**SUBJECT** PROJECT CONCEPT REPORT APPROVAL

SUBJECT PROJECT CONCEPT REPORT

PROJECT CONCEPT REPORT  
STP-037-1(18) & BHF-037-1(19) Bibb County  
Riverside Drive Widening from Hall Road to Northside Drive  
DATE: September 27, 1995

Alternate  
1

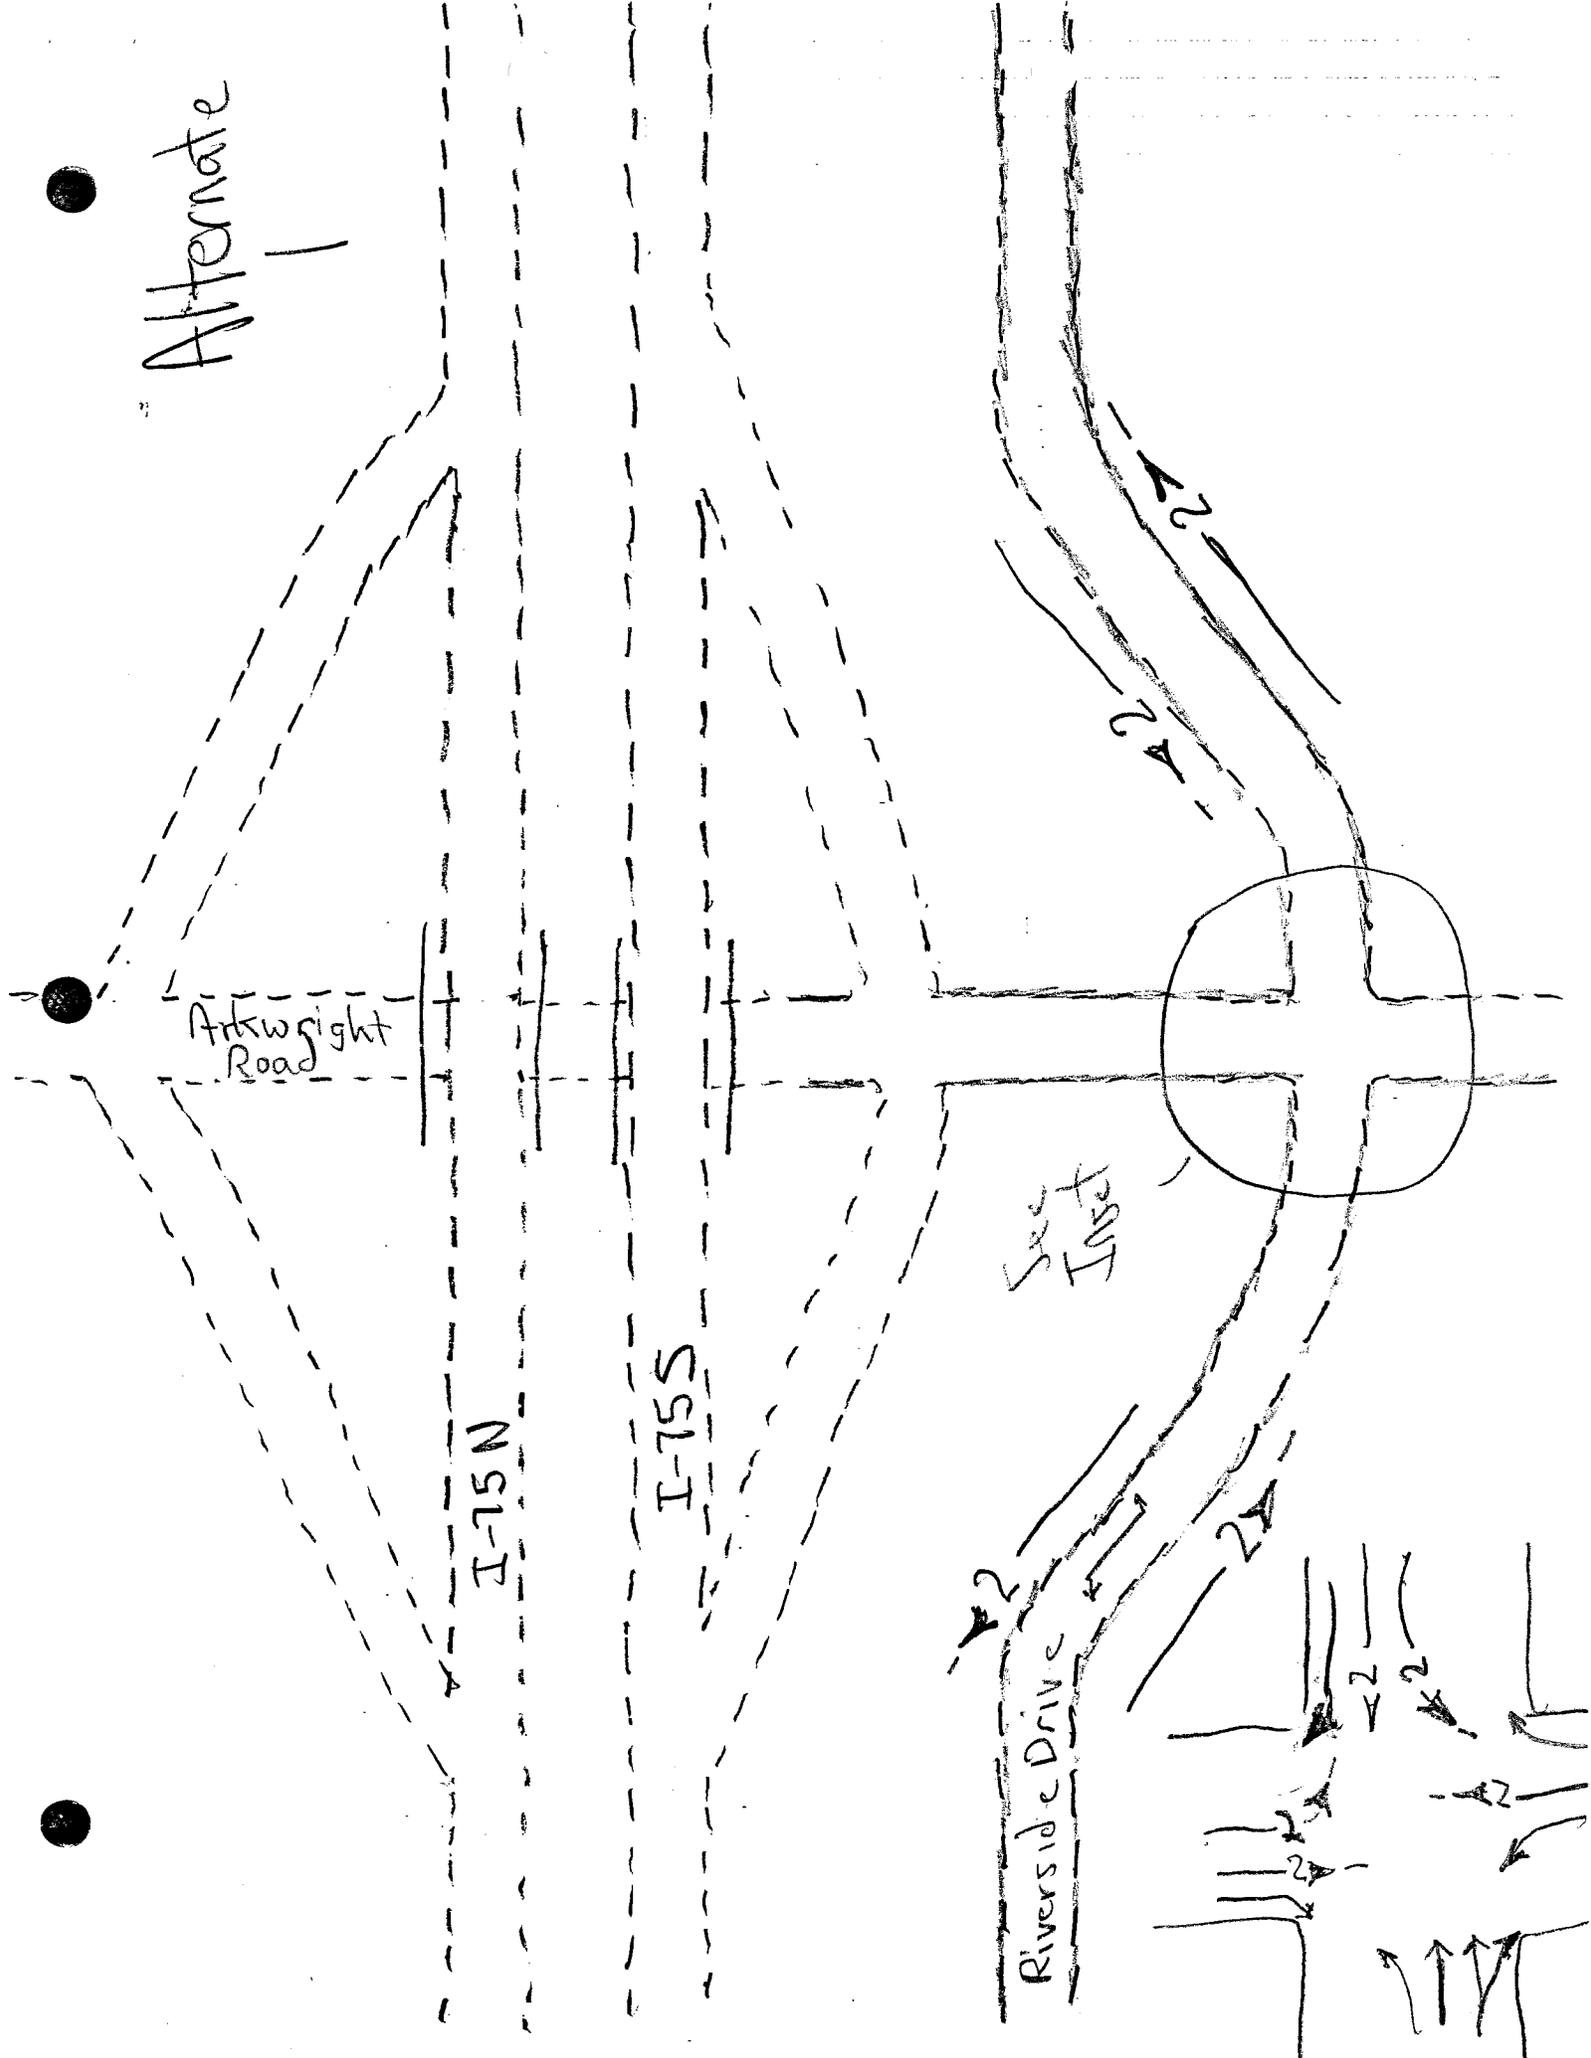
The concept as originally presented at the concept meeting of May 18, 1993 called for the at grade intersection of Riverside Drive and Arkwright Road to be retained with widening as necessary in an attempt to improve the level of service of the intersection. Because of the intersection's proximity with the Arkwright Road\I-75 interchange, all lane tapers and storage lengths were of minimum allowable design standards. The concept was not met with enthusiasm by either the Department or the local officials. The Urban Design office agreed to do further study on the project in an effort to obtain a more satisfactory design. This concept is referred to as Alternate 1 in this report and on the attached cost estimate.

# Alternate 2a

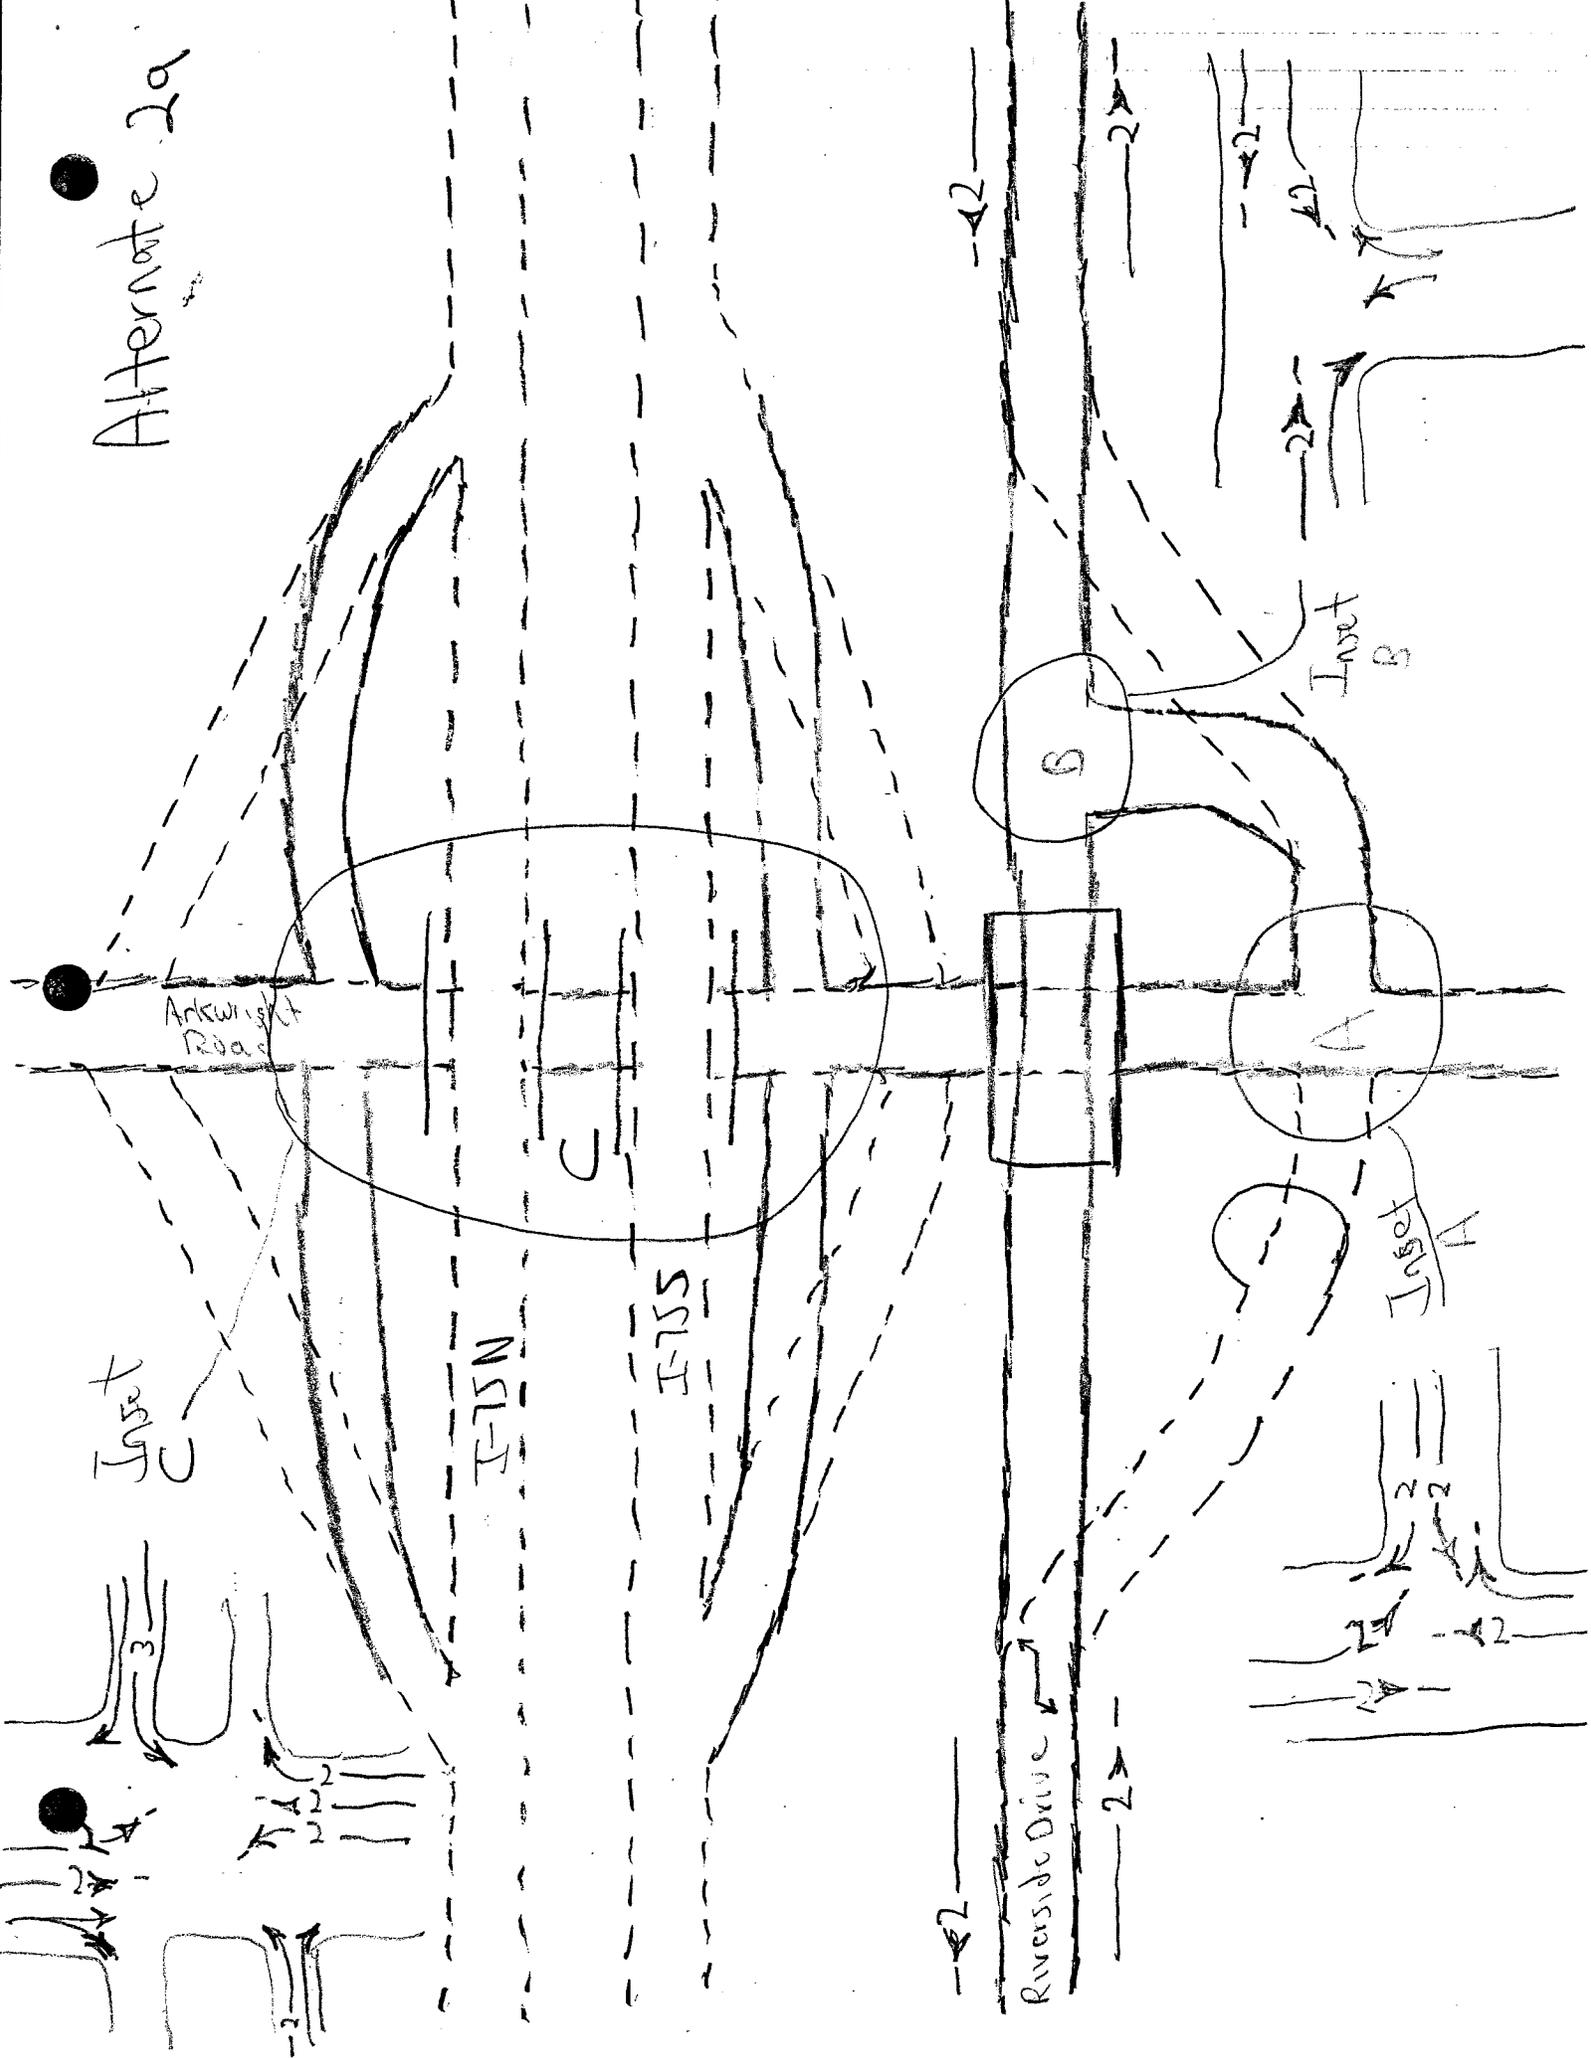
In regard to the Arkwright Road interchange, we have reviewed the preliminary concept and, based on our staff's professional opinion, we feel that the concept is appropriate. Please keep us informed as the concept progresses.

These projects are in the STIP. I recommend these project concepts be approved for Alternate 2A.
